Licence Number	L6617/1992/15
Licence Holder	Nifty Copper Pty Ltd
ACN	074 145 636
Registered business address	Level 5, 197 St Georges Terrace PERTH WA 6000
File Number:	DER2014/001324-2
Premises	Nifty Copper Operation Legal description – Mining Tenement AM7000271 TELFER WA 6762
Date of Amendment	12 July 2019

Amendment

The Licence Holder has applied for a Licence amendment to allow construction activities to raise the embankments of TSF 1 by 2.5m to provide for further tailings storage capacity.

Map of Monitoring Locations

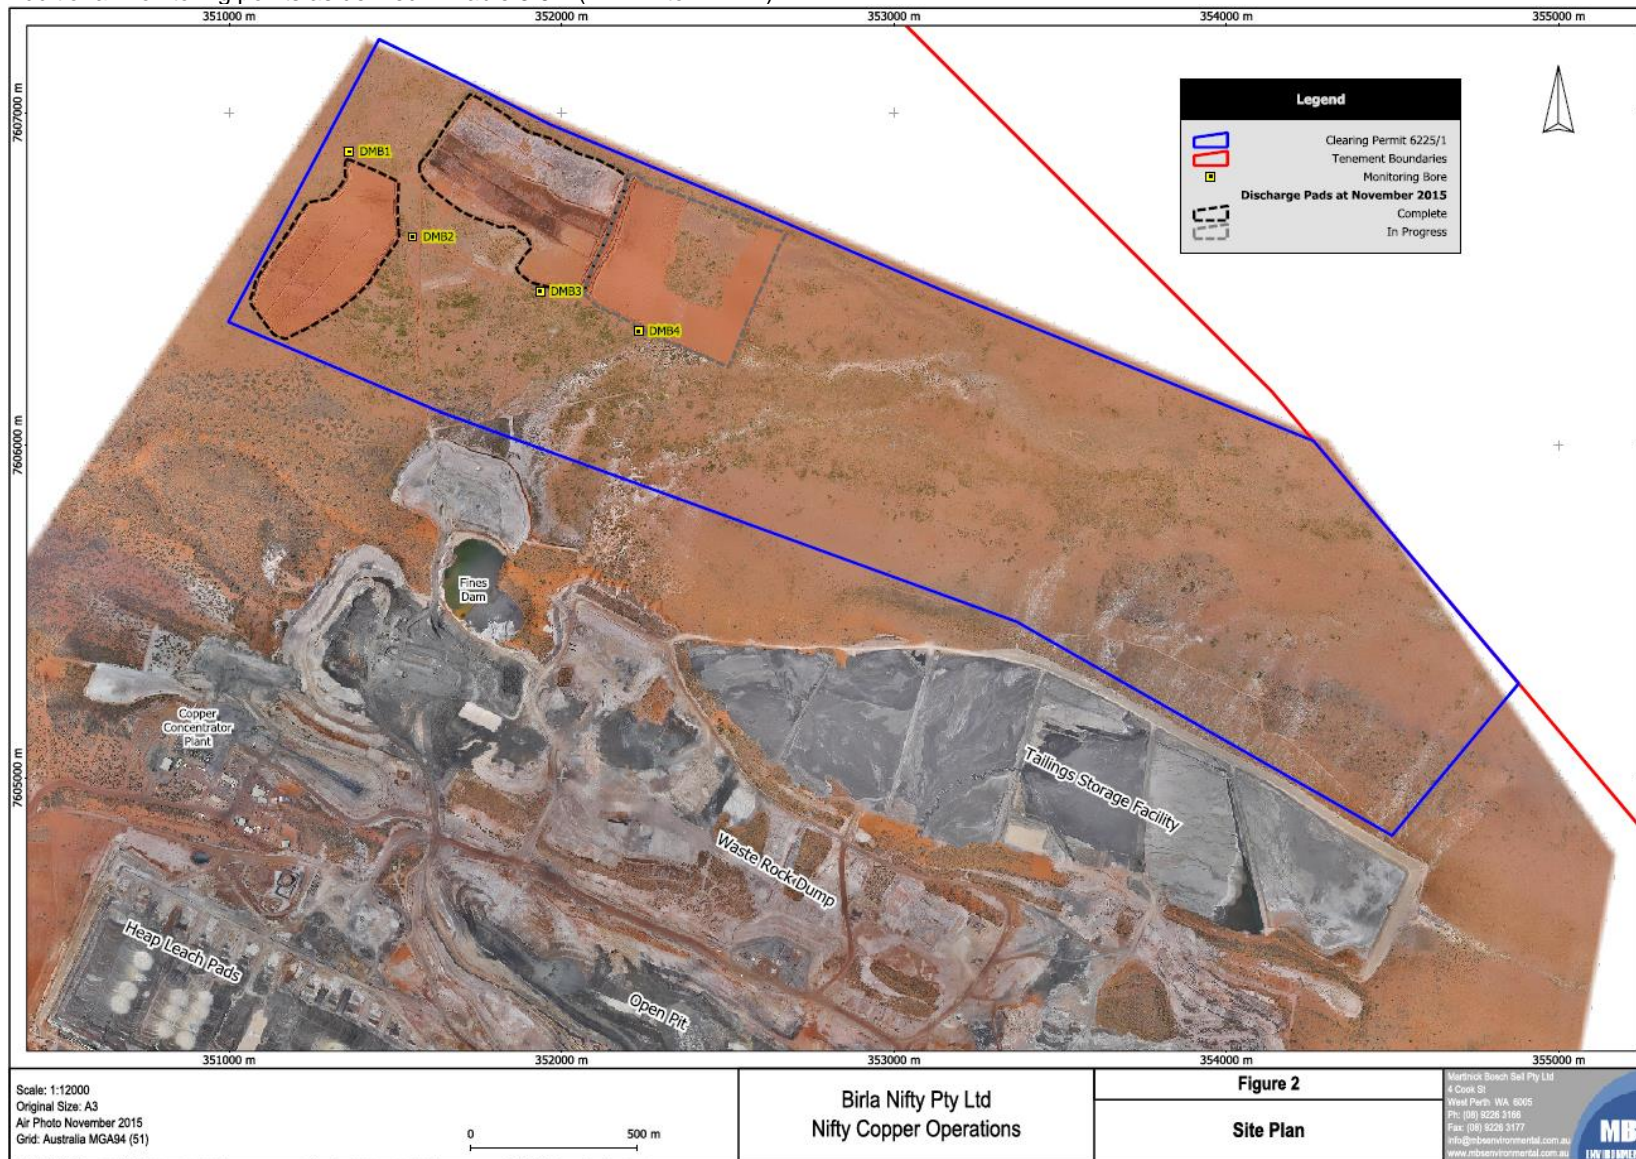
7. Schedule 1 of the Licence is amended by the deletion of the Map of Monitoring Locations and the inclusion of the map below.

The locations of the monitoring points defined in Tables 3.6.1 and 3.6.2 are shown below
